Bulletin No.: 09-07-30-004J

Service Bulletin

Subject: Slips in Reverse or Third, Delayed Reverse or Drive Engagement, DTC P0776, P2715, P2723, Harsh 2-3 Shifts (Inspect 1-2-3-4 / 3-5-R Housing and Pump Seal Rings)

Models: 2006-2009 Cadillac STS-V, XLR, XLR-V
2007-2008 Cadillac Escalade, Escalade ESV, Escalade EXT
2006-2009 Chevrolet Corvette
2007-2008 Chevrolet Silverado
2008 Chevrolet Suburban
2007-2008 GMC Sierra, Sierra Denali, Yukon Denali, Yukon XL Denali
2008 GMC Yukon XL
2008-2009 HUMMER H2
2008-2009 Pontiac G8
Equipped with 6L80 or 6L90 Automatic Transmission (RPOs MYC, MYD)

2715381

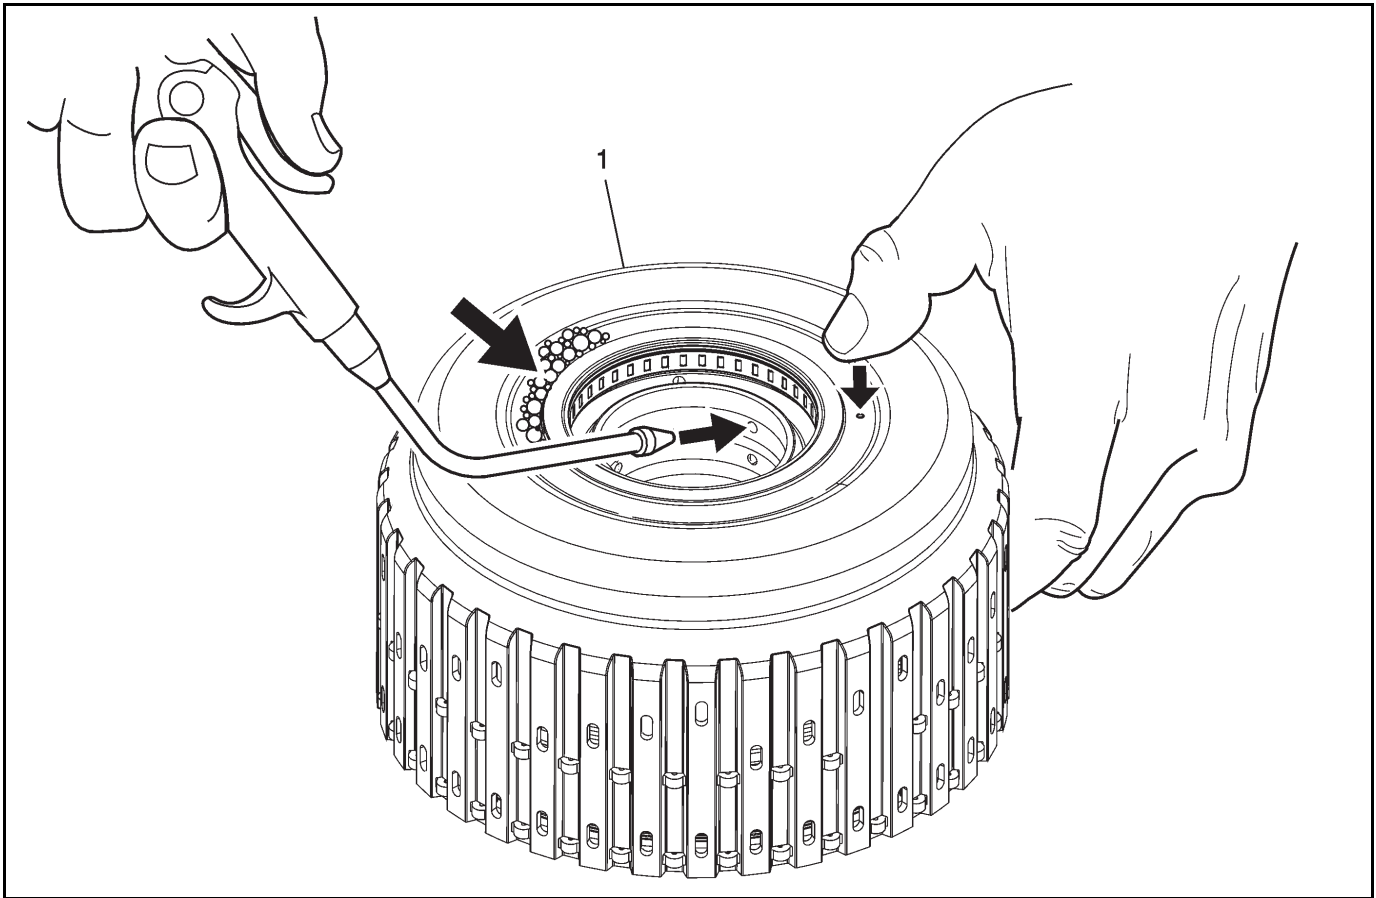
This condition may be caused by a cracked 1-2-3-4 / 3-5-R clutch housing.

Inspect the 1-2-3-4 / 3-5-R clutch housing for a possible cracked weld. The housing can be inspected either assembled or disassembled.

1. Apply soap compound to the weld area of the housing.
2. Hold your thumb over the air bleed passage.
3. For a fully assembled 1-2-3-4 and 3-5 reverse clutch housing, spray compressed air into the 3-5R clutch feed hole and inspect the weld area for bubbles.
4. If bubbles are detected, a new housing is required.

2539550

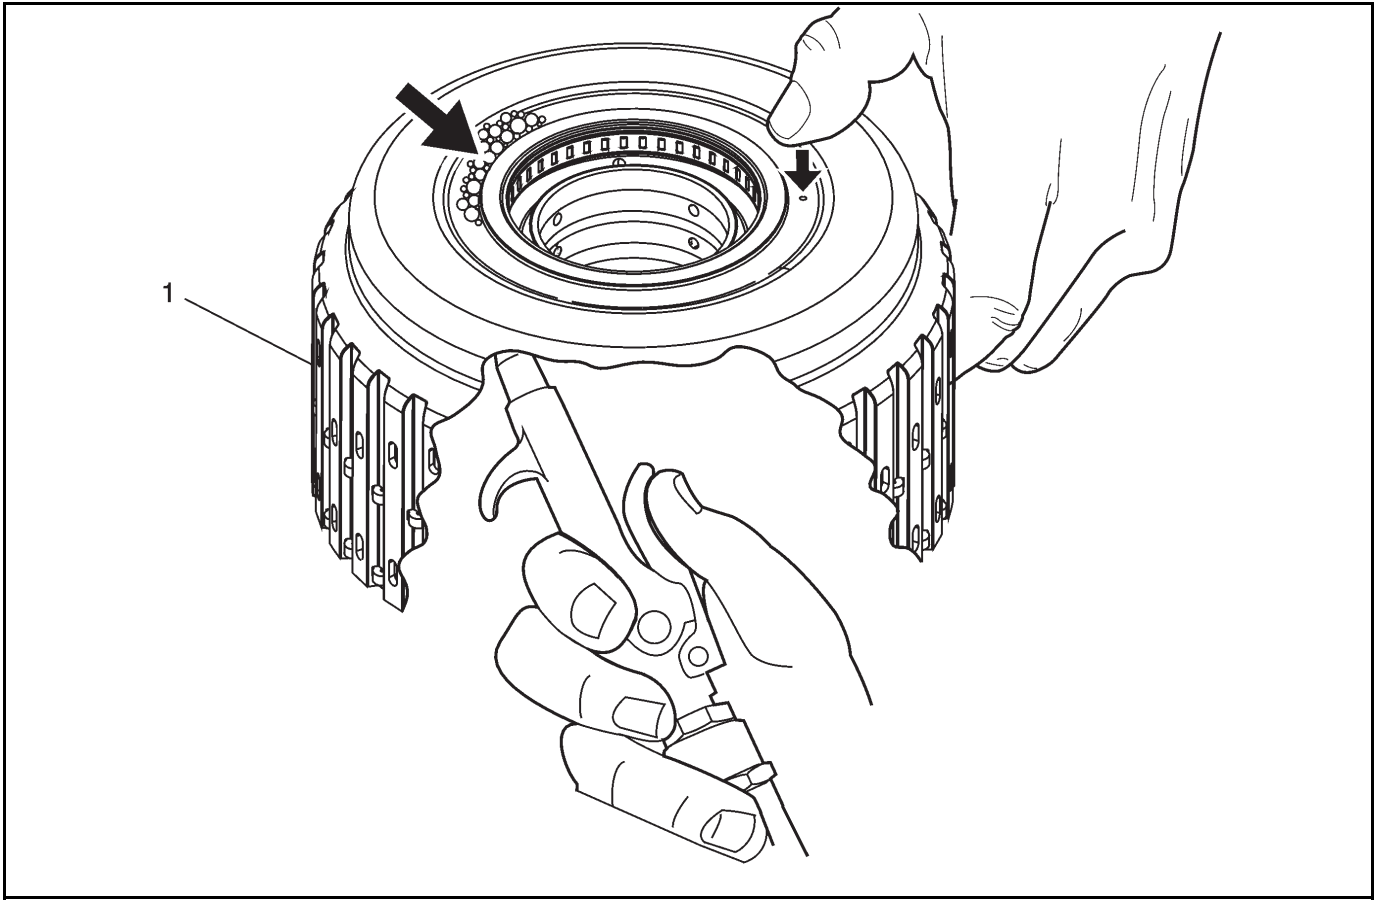
Inspect the 1-2-3-4 / 3-5-R clutch housing for a possible cracked weld.

1. Apply soap compound to weld area of the housing.
2. Hold your thumb over the air bleed passage.
3. Spray compressed air into the housing and inspect the weld area for bubbles.
4. If bubbles are detected, a new housing is required.

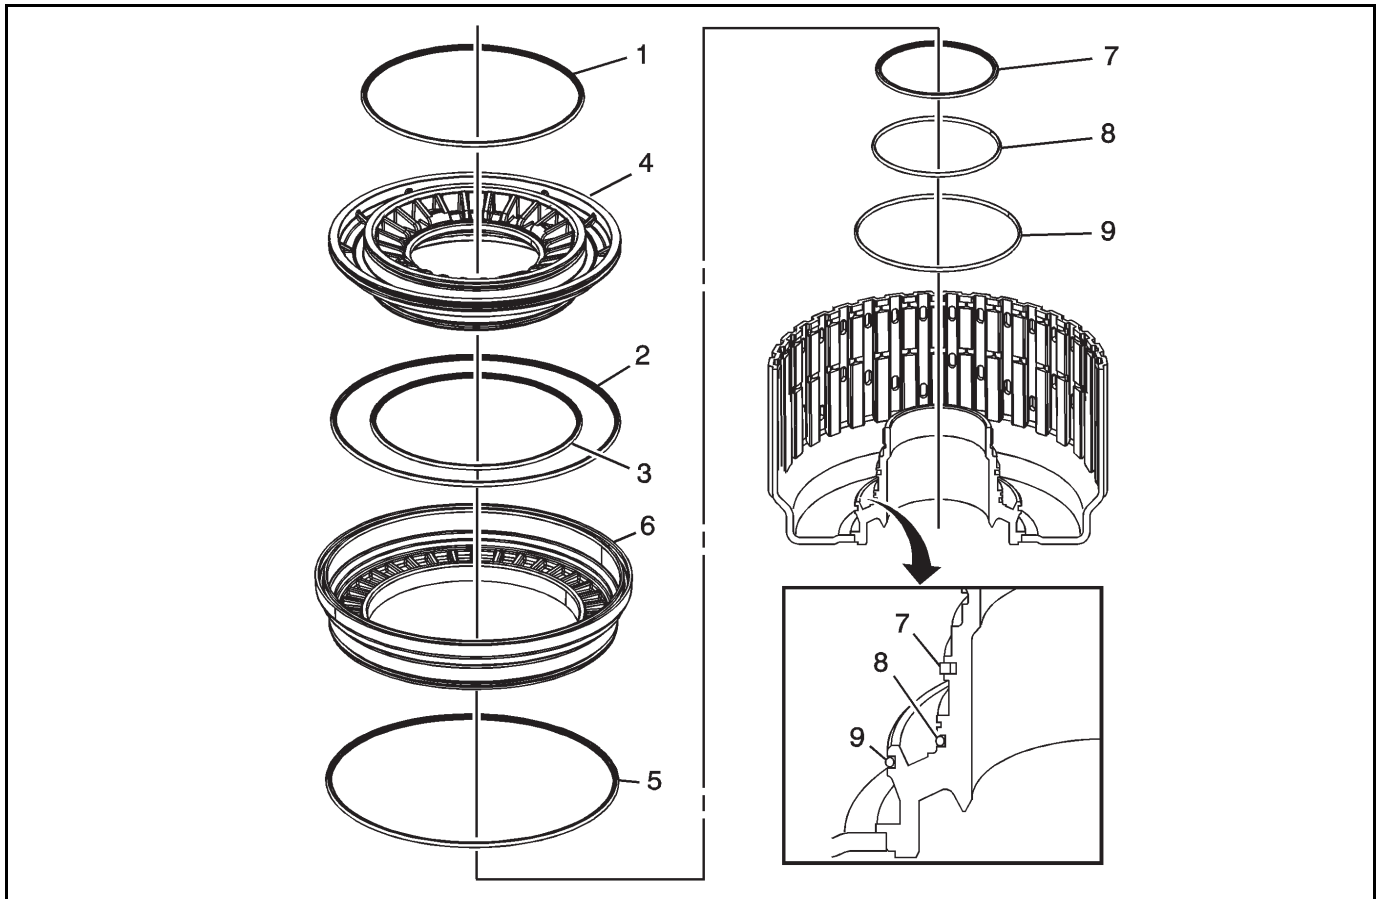
Important: When installing a new 1-2-3-4 / 3-5-R housing into a 2007 or older 6L80, be sure to install all three (3) inner seals (7, 8, 9 in illustration below). Failure to install these seals can result in no reverse, no forward or distressed clutches.

Important: The 6L80 transmission had a design change to the 1-2-3-4 piston, 1-2-3-4 piston housing and the 3-5-R piston for the 2008 model year. Installation of a 2008, 6L80 complete housing assembly into a 2007 or older 6L80 may result in a 2-3 shift flare or 3-5-R clutch distress.

2219005

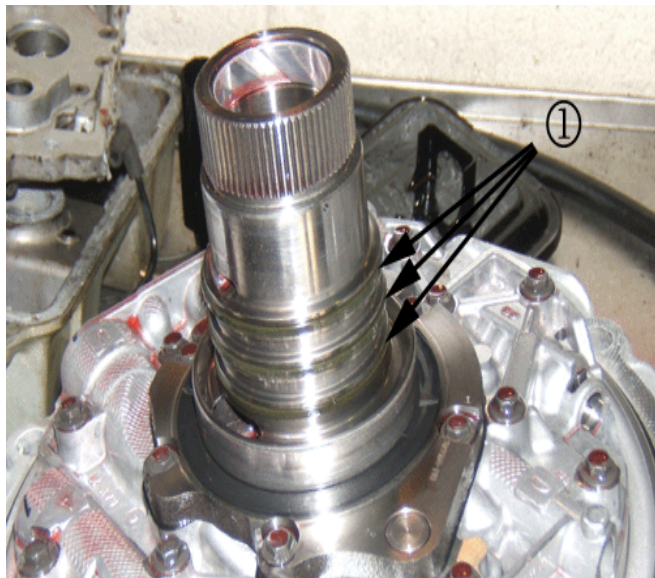
A harsh 2-3 shift condition may be caused by leaking 1-2-3-4 and 3-5-R clutch fluid seal rings (1) on the transmission fluid pump cover assembly.

1555367

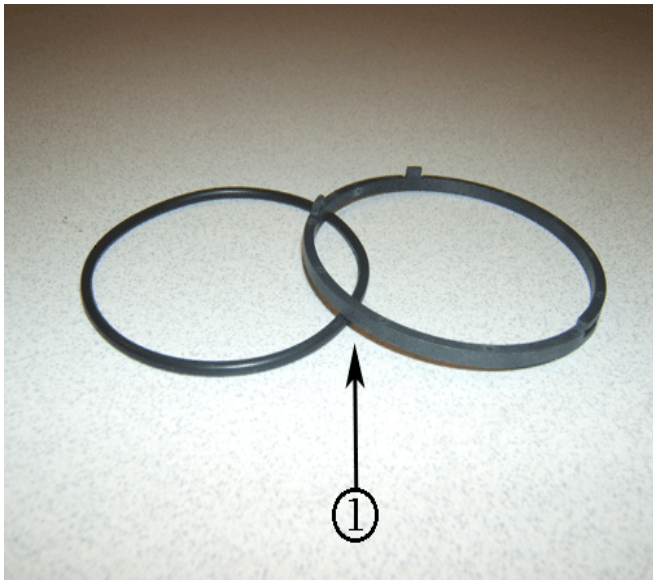
Inspect the fluid seal rings. Transmissions in 2006, 2007, 2008 and early build 2009 models used a 1- piece design seal ring in production. Starting December 2008, a 2-piece seal ring design was implemented. The 1-piece seal ring design may cause a harsh 2-3 shift due to leakage. This is typically a low mileage issue. If the seal rings are a 1-piece design they should be replaced with new 1-piece design seal rings. It is not necessary to replace the pump cover.

Notice: The clutch fluid seal rings must be installed in a specific way. Failure to install new clutch fluid seal rings in the proper orientation may cause a repeat harsh 2-3 shift. Refer to 1-2-3-4 and 3-5 Reverse Clutch Fluid Seal Ring Installation (6L80/90) in SI for correct installation.
